Permit of Authorization to Construct an On-Site Sewage Facility Permit Valid For One Year From Date Issued

Permit Number: 116955
Issued This Date: 12/18/2023
This permit is hereby given to: Guy and Jennifer Souheaver

Subject: RE: Encountered Feature at 457 Eden Ranch Drive, New Braunfels, Tx

A feature (ER-01) was encountered at a residential property during excavation for a septic system (OSSF permit 116955) on 20 March 2024 at 457 Eden Ranch Drive, New Braunfels, Texas. Zara Environmental LLC (Zara) geologists Michael Jones, P.G., and Kara Posso, P.G., conducted reconnaissance excavation and evaluation of the feature on 28 March 2024.

Figure 1. Field sketch of feature ER-01.

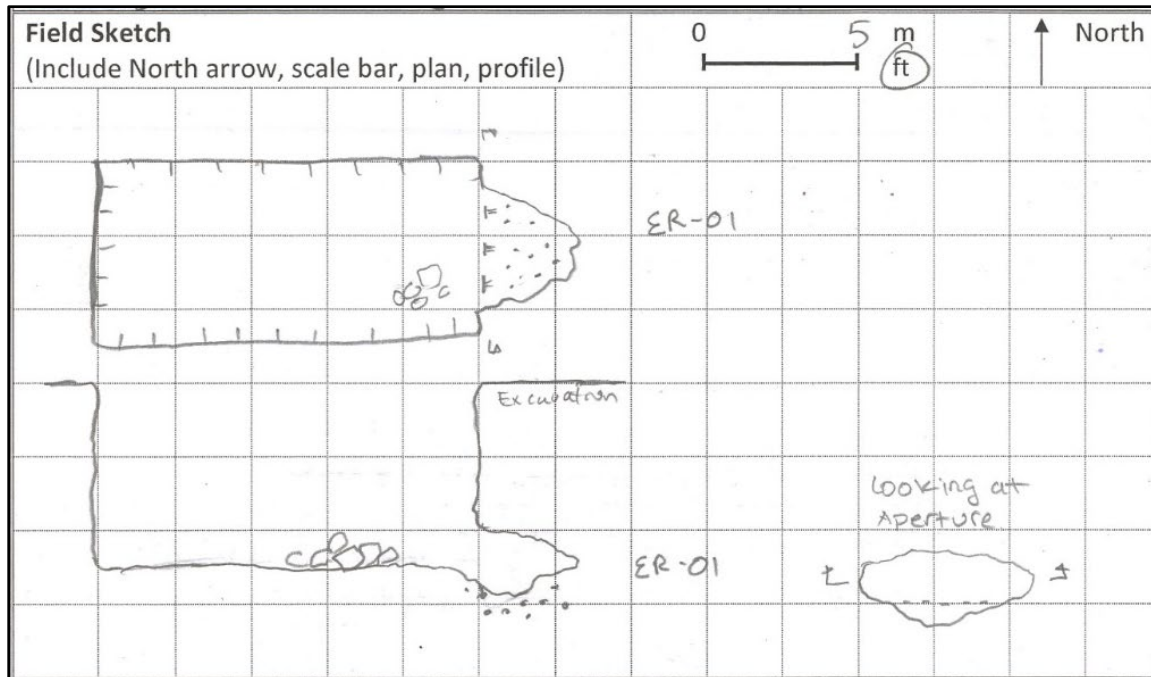
Feature ER-01 was encountered on the east side of an excavation that was 12.5 feet long by 5 feet wide by 7 feet tall (Figure 1 and Figure 2). The top of the feature was located 5 feet below the surface in epikarst bedrock. Geologists spent approximately 15 minutes performing hand excavation on the feature and ultimately measured as being 5.5 feet long by 2 feet tall and extended into bedrock beyond the excavation for 3 feet (Figure 3 and Figure 4). The feature was developed along a bedding plane and qualified as an “other natural bedrock feature”. It was an alteration zone of high porosity filled with leached “punk rock” (soft, powdery material) grading into hard, unaltered rock in the Dolomitic Member of the Kainer Formation (Kkd). The fine, powdery leached material was highly friable and easily excavated, indicating that it likely has a moderate relative infiltration rate. However, the feature appeared to be an isolated and there were no open void apertures, lateral mesocavernous conduits, or other downward trending conduits within the feature; therefore, geologists concluded that ER-01 does not qualify as a sensitive recharge feature. Below is a field sketch of the feature with photos of the interior, and an exhibit of the feature location on the property has been included as the final attachment.

Although feature ER-01 did not qualify as a sensitive feature per the TCEQ criteria, due to the inherent heterogeneous nature of karst hydrogeology in the Edwards Aquifer Recharge Zone and the potential for groundwater contamination to occur from leaking septic system infrastructure, it is recommended that existing excavation be backfilled with native materials and the septic system be relocated 50 feet away from feature ER-01 to maximize the success of the installation design and prevent potential groundwater contamination.

On April 1, 2024 a site assessment was conducted by the EAPP and upon review, the EAPP is in agreement that the feature is not sensitive and agree that the recommendations for mitigation are acceptable.
